To: City of Sunnyvale Planning Department
From: Kurt Fouts – Arborist Consultant
Re: City Comments dated 1/16/19
Date: 1/23/2019

Project: 2018-7737

Address: 898 E EVELYN AV

Description: Tentative Parcel Map, Special Development Permit, & Design Review to subdivide an existing duplex into two separate condos

Sheet T1
of 1

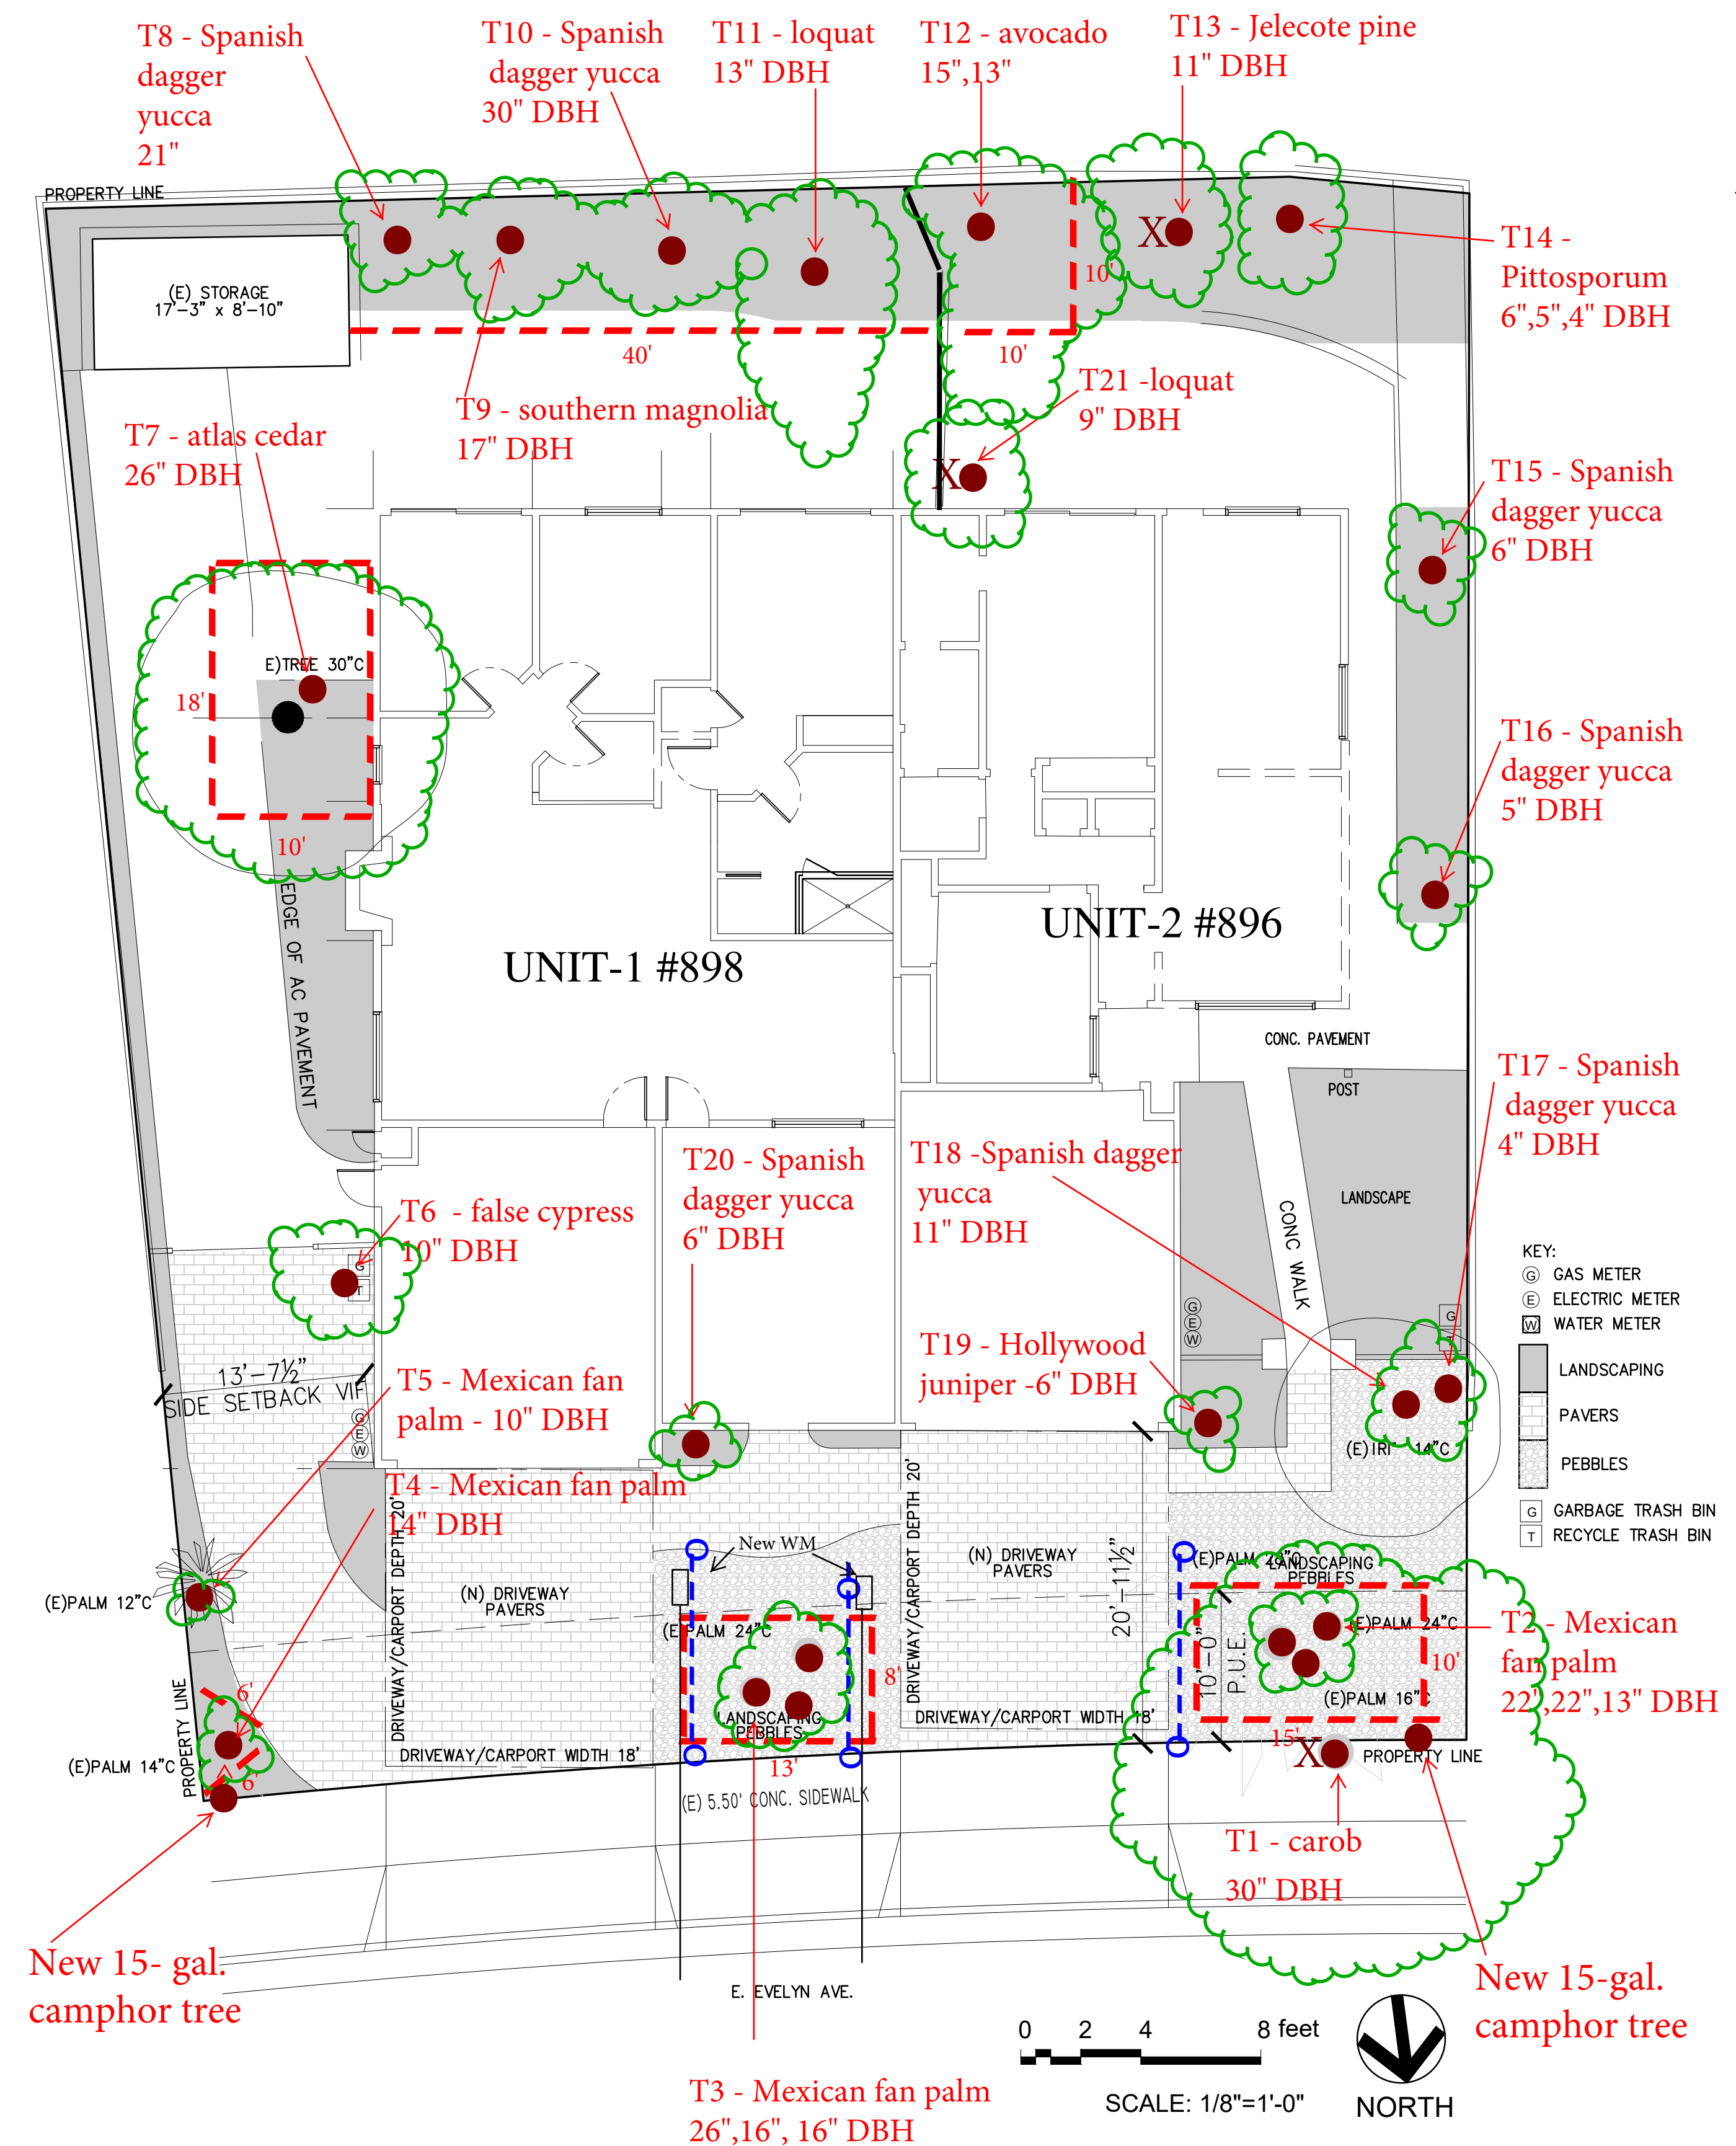
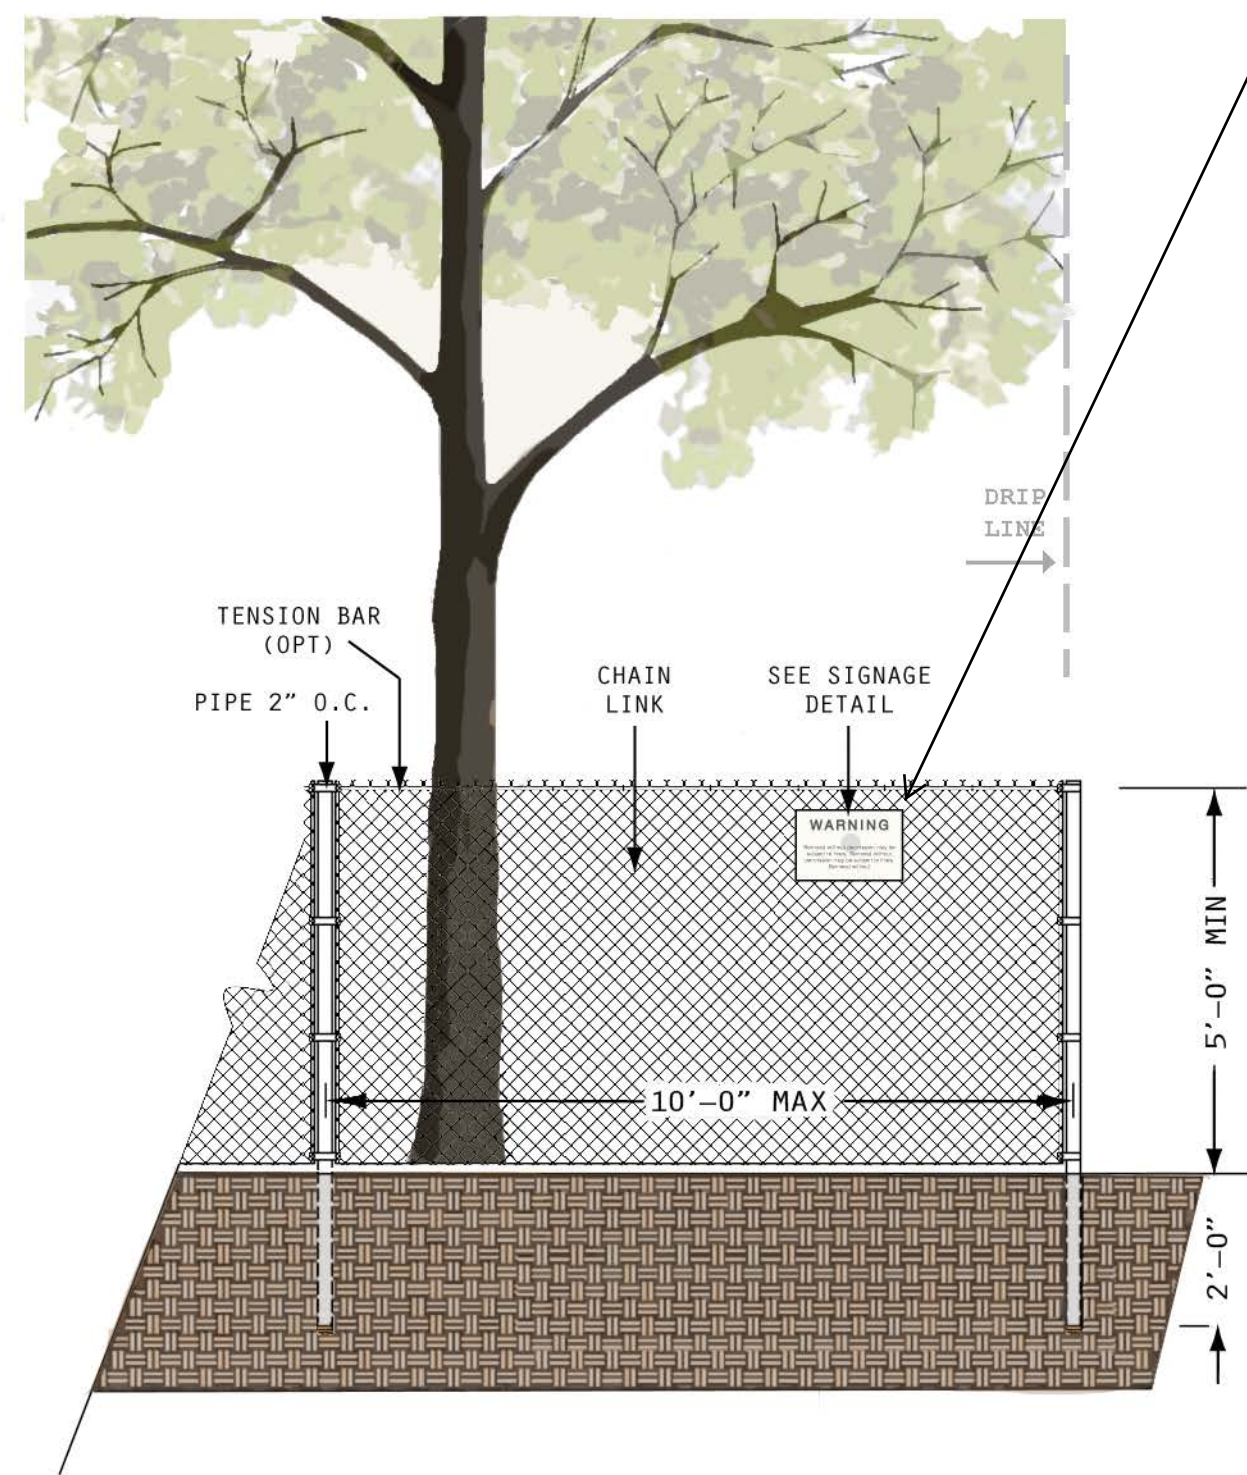
This letter and attached plan are a revision to my arborist report for the above property, dated 10/24/2018. As per city comments, two 15-gallon camphor trees (*Cinnamomum camphora*), will be planted at the 898 Evelyn Avenue site as replacement trees for the carob tree that will be removed.

The attached Tree Protection Plan, Sheet T1 has been revised to include the planting locations for two camphor trees. The planting locations shown are greater than 10 feet from the sanitary sewer laterals serving the remodeled home.
